**9. Levan-Sterling Subdivision; KPB File 2022-125R1**

KPB File 2022-125R1  
 T 05N R 09W SEC 12  
 Sterling

**LEVAN-STERLING SUBDIVISION**

STAFF REPORT

**BUILDING SETBACK LAYOUT APPLICABLE TO ALL LOTS CREATED BY THIS PLAT**

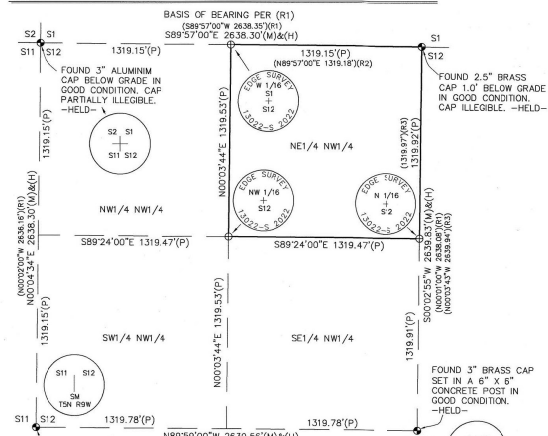
New utility easement as identified in note 2 as “the front 10’ of the 20’ Building Setback and the entire 20’ Building Setback within 5’ of side lot lines”. A typical building setback detail is provided but does not depict within side lot lines. **Staff recommends the depiction be updated to show the 20 foot easement within 5 feet of the side lot lines.**

**PRELIMINARY PLAT**

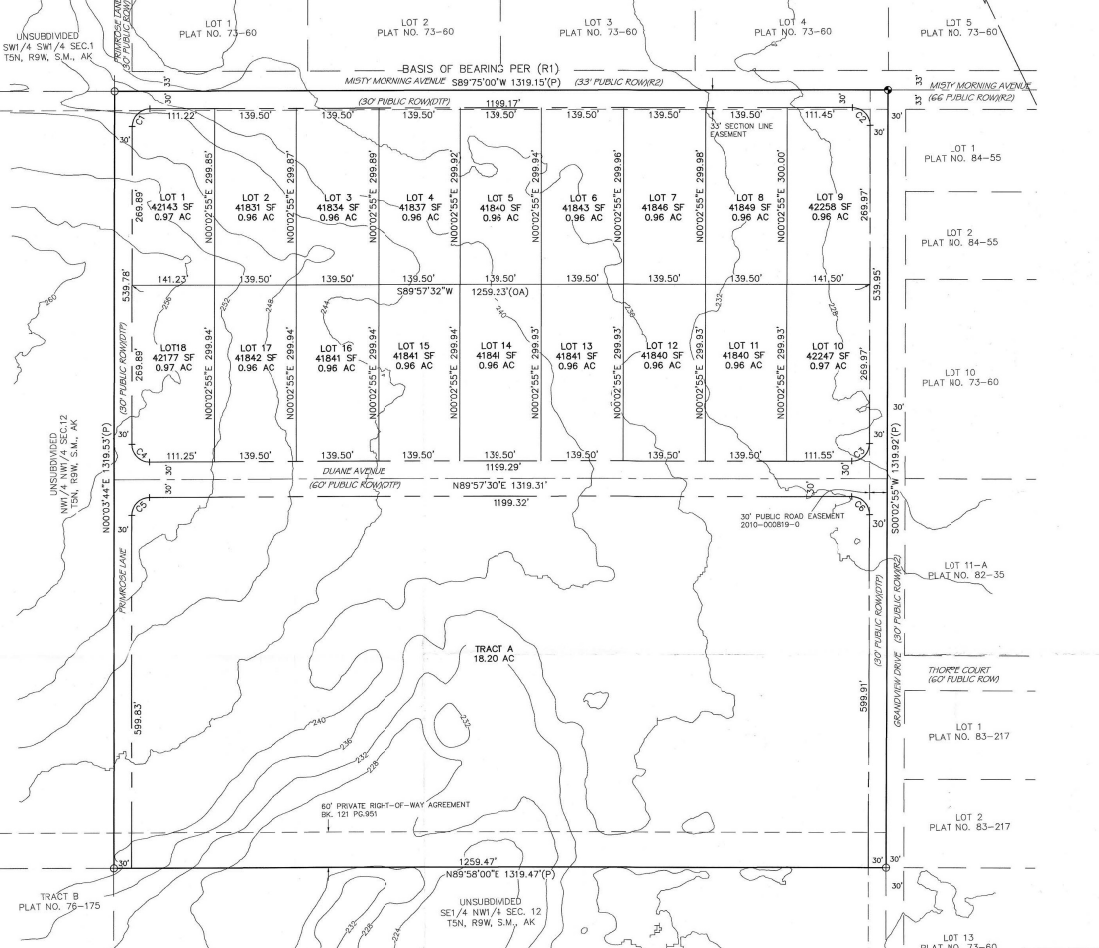
Along the eastern boundary the plat shows a 30-foot right-of-way dedication for Grandview Drive to bring the right-of-way into compliance for width. Grandview Drive is constructed and maintained by the borough. This dedication is occurring atop a public easement granted by recorded document. **Staff recommends the easement label include the recording district or “KRD”.**

The northern portion complies with block length. The removal of the dedication along the southern boundary creates a non-compliant block. An exception has been requested for block length. The removal of the southern dedication also results in dead end dedication and an exception to not dedicate a turnaround area has been requested.

A private right-of-way easement exists along the southern boundary that contains a high pressure pipeline. **Staff recommends the label include the recording district or “KRD”.**

**Site Investigation:** The preliminary plat does not contain any steep areas or low wet lands. The land appears to be vacant with no neighboring encroachment issues. As discussed under the legal access portion of the staff report, the rights-of-way along the north and west are constructed and maintained by the borough. **Staff recommends the terrain be removed from the final plat.**

*Update the plat note numbers.*

**Staff recommendation:** Kenai Recording District should be present within the title block area.

**Staff recommendation:** An acceptance for the new dedications is required to be signed by the KPB.

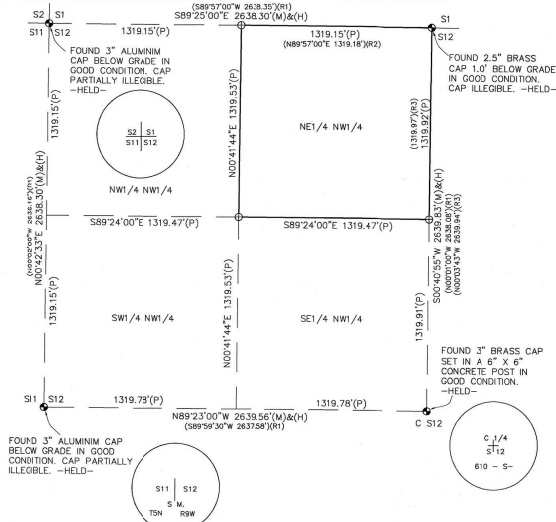
New utility easement as identified in note 2 as “the front 10’ of the 20’ Building Setback and the entire 20’ Building Setback within 5’ of side lot lines”. A typical building setback detail is provided that shows the setback and utility easements as described within the plat note. **Staff recommends the plat note include “granted by this plat”.**

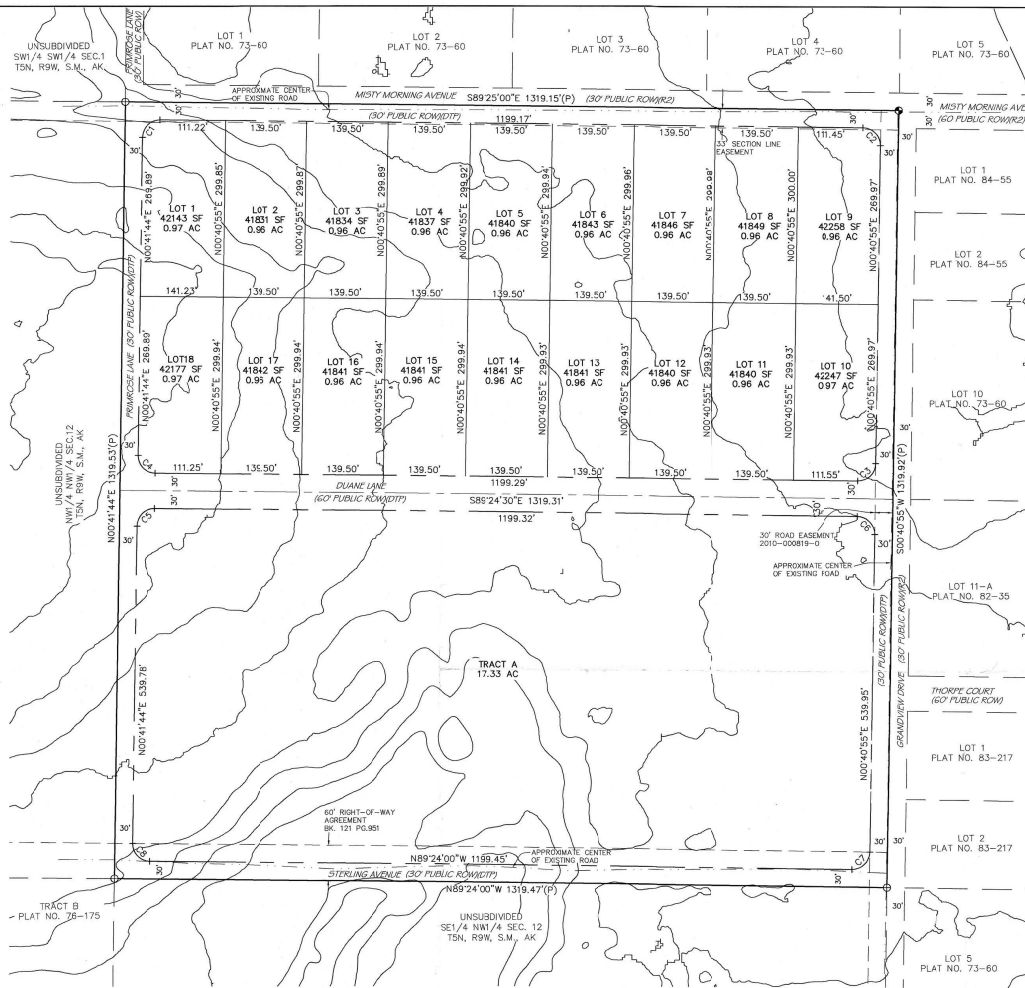
Along the eastern boundary the plat shows a 30-foot right-of-way dedication for Grandview Drive to bring the right-of-way into compliance for width. Grandview Drive is constructed and maintained by the borough. This dedication is occurring atop a public easement granted by recorded document. **Staff recommends the easement label include "public" or a plat note be added that includes the details and description of location and states it is now within the dedicated portion of Grandview Drive.**

- providing a 30 foot dedication as currently proposed and make sure the pipeline is within the edge of the right-of-way or north of the dedication, or
- provide a reduced width for the right-of-way to not have the dedication atop the pipeline, or
- provide a full 60 foot dedication that is north of the existing pipeline.

**Staff recommendation:** *North half of Misty Morning Avenue is 33' change on drawing*
- D. A vicinity map, drawn to scale showing location of proposed subdivision, north arrow if different from plat orientation, township and range, section lines, roads, political boundaries, and prominent natural and manmade features, such as shorelines or streams;

**Staff recommendation:** *The Misty Morning Avenue label appears along the right-of-way known as Robinson Loop Road. Add "Loop Road" to Scout Lake Loop Road Label. The Funny River label in section 24 should have "Road" added. If this is to reference the river the line depiction should be added to make it clear.*

- Update plat note 5 to include KPB Code reference. "Roads must meet the design and construction standards established by the borough in order to be considered for certification and inclusion in the road maintenance program (KPB 14.06)."
- Remove "nominal five acres" from the wastewater note.

**Staff recommendation:** *Per the Certificate to Plat the ownership is under Mr. Levan's name only. Correct the ownership statement to be in the singular and remove Alice Levan from the statement. Comply with 20.60.190.*
